SUBJECT: 7.3 L Engine Oil Temperature (EOT) Sensor Running Change

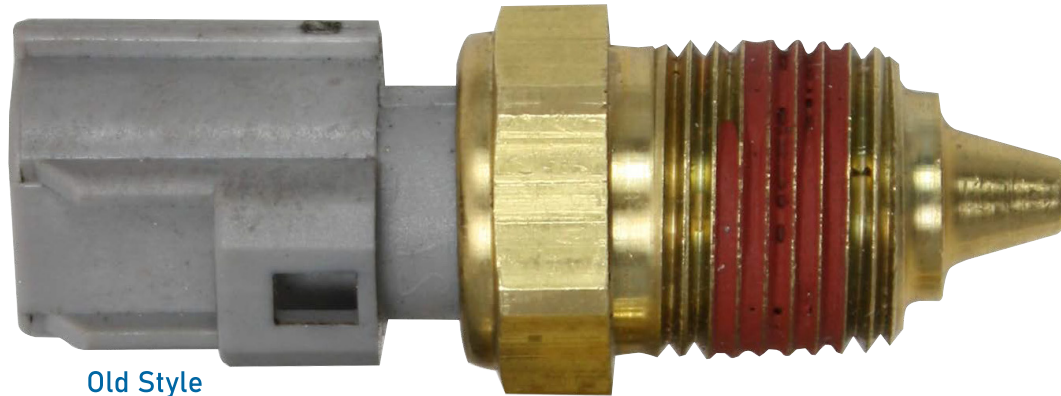
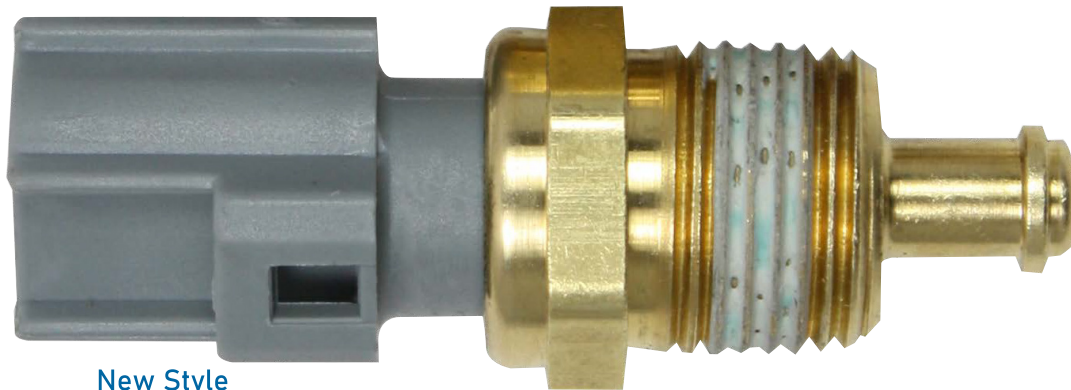
Ford has made a running design change and part number update to the 7.3 L Engine Oil Temperature (EOT) Sensor for model years 1994-2003. While the fit and function of the new sensor has not changed from the original sensor, the design change is distinguishable in the side-by-side photos below:

Alliant Power will supply the new design sensors once existing stock is depleted. While the Alliant Power part number will not be changed, the table below includes OEM part numbers of both sensors for your cross-reference information.
